[Docket No. FAA-2016-9254; Directorate Identifier 2015-CE-030-AD; Amendment 39-18948; AD 2017-14-04]

Airworthiness Directives; Piper Aircraft, Inc. Airplanes

ACTION: Final rule.

SUMMARY: We are superseding Airworthiness Directive (AD) 95-26-13 for certain Piper Aircraft, Inc. Models PA-28-140, PA-28-150, PA-28-151, PA-28-161, PA-28-160, PA-28-180, PA-28-181, PA-28-235, PA-28-236, PA-28R-180, PA-28R-200, PA-28R-201, PA-28S-160, PA-28S-180, PA-32-260, PA-32-300, PA-32-301, PA-32-301T, PA-32R-300, PA-32R-301 (SP), PA-32R-301 (HP), PA-32R-301T, PA-32RT-300, PA-32RT-300T, and PA-32S-300 airplanes equipped with oil cooler hose assemblies that do not meet certain technical standard order (TSO) requirements. AD 95-26-13 required inspections, replacement, and adjustment of the oil cooler hose assemblies, as well as providing for a terminating action. This AD retains all of the requirements of AD 95-26-13 and adds language to clarify those requirements. This AD was prompted by several inquiries asking for clarification of the AD's applicability and compliance requirements. We are issuing this AD to correct the unsafe condition on these products.

Figure 1 to paragraphs (g) and (h) of this AD: Oil cooler

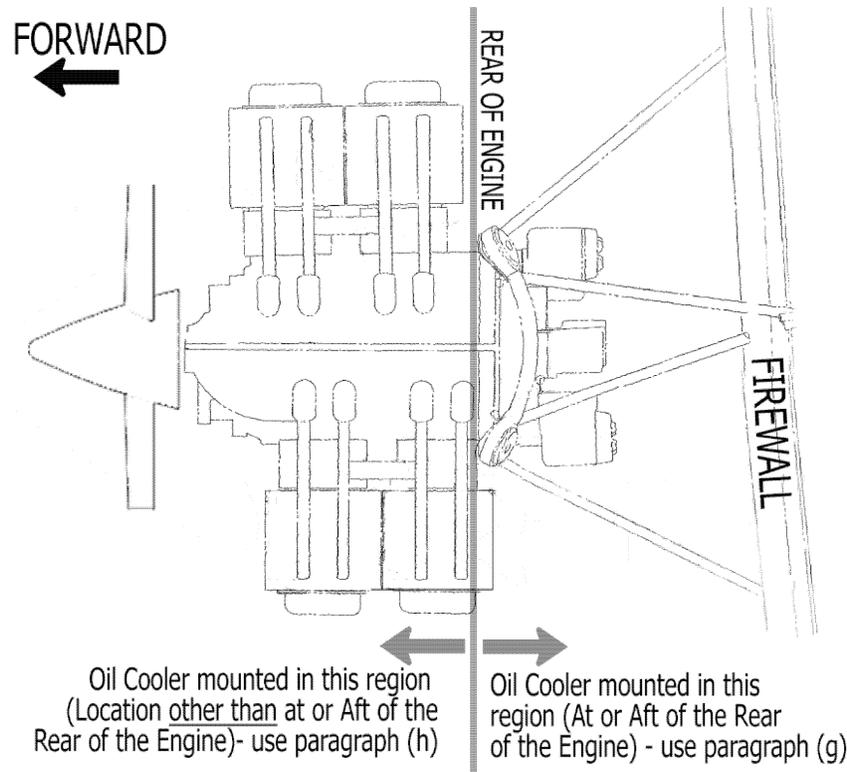
For any oil cooler hose assemblies that do not meet TSO–C53a, Type D requirements: Within the next 100 hours time-in-service (TIS) after February 5, 1996 (the effective date retained from AD 95–26–13), and repetitively thereafter at intervals not to exceed 100 hours TIS, inspect the fire sleeve of each oil cooler hose assembly for soaked oil, a brownish or whitish color, and any evidence of brittleness or deterioration as a result of heat or oil seepage. See figure 1 to paragraphs (g) and (h) of this AD for additional information.

after February 5, 1996 (the effective date retained from AD 95-26-13), and repetitively thereafter at intervals not to exceed 100 hours TIS, inspect the fire sleeve of each oil cooler hose assembly for soaked oil, a brownish or whitish color, and any evidence of brittleness or deterioration as a result of heat or oil seepage. See figure 1 to paragraphs (g) and (h) of this AD for additional information.

Figure 2 to paragraph (h)(2) of this AD: Acceptable clearances

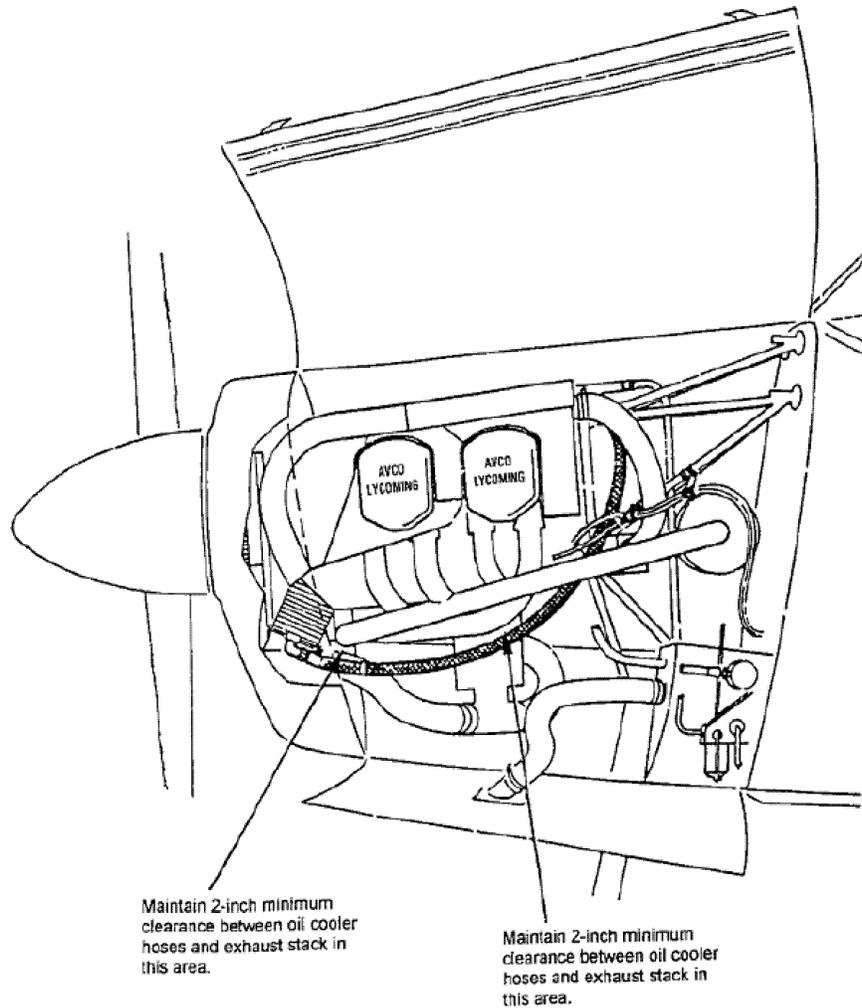
(h) of this AD for additional information. If the conditions listed in paragraphs (h)(2)(i) through (iii) of this AD are not met, before further flight, make any necessary adjustments. See figure 2 to paragraph (h)(2) of this AD for additional information.

(i) The oil cooler hose assemblies pass underneath and behind the electrical ground cable and in front of the lower of the two engine mounts.

(ii) The oil cooler hose assemblies are secured to the engine mount strut and a clearance of at least 2 inches exists between the oil cooler hose assemblies and the exhaust stack.

(iii) Oil cooler hose assemblies with a minimum outer diameter of 0.75 inch are installed with a bend radius of at least 6.5 inches.

Appendix 1 to AD 2017-14-04

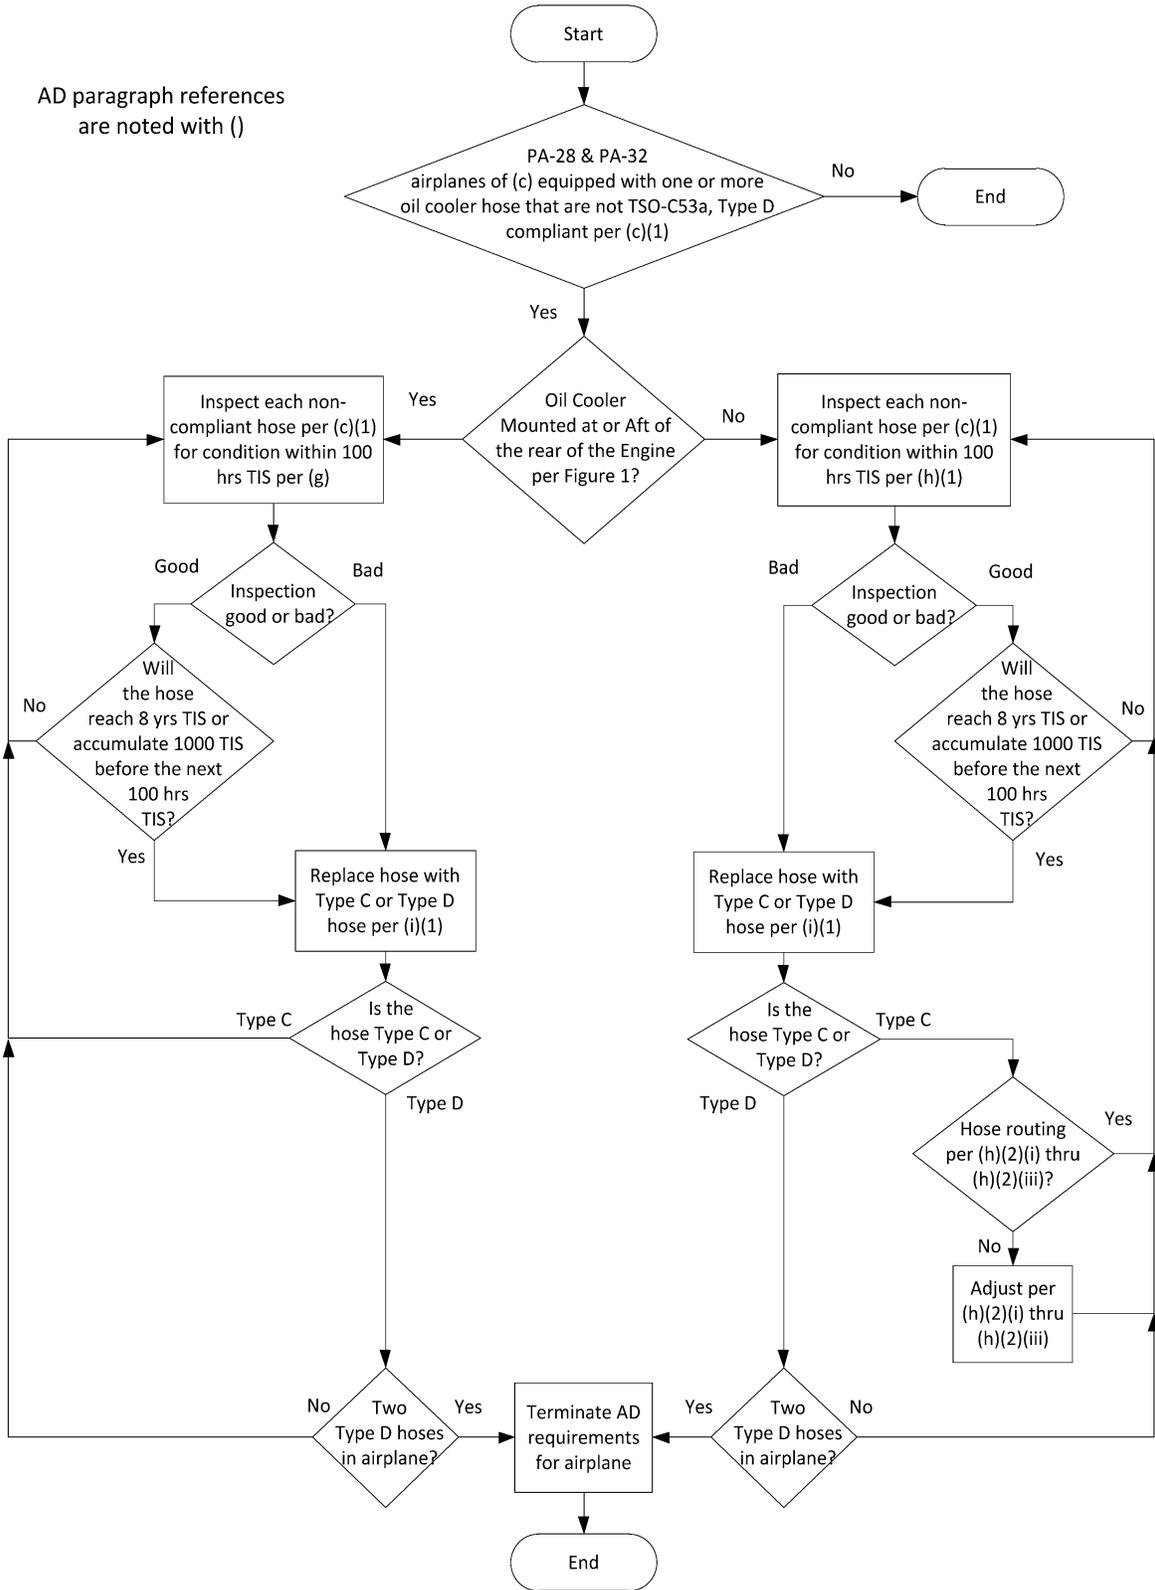
Comply with this AD within the compliance times specified, unless already done. You may review the flow chart found in appendix 1 to assist you in complying with the actions of this AD.
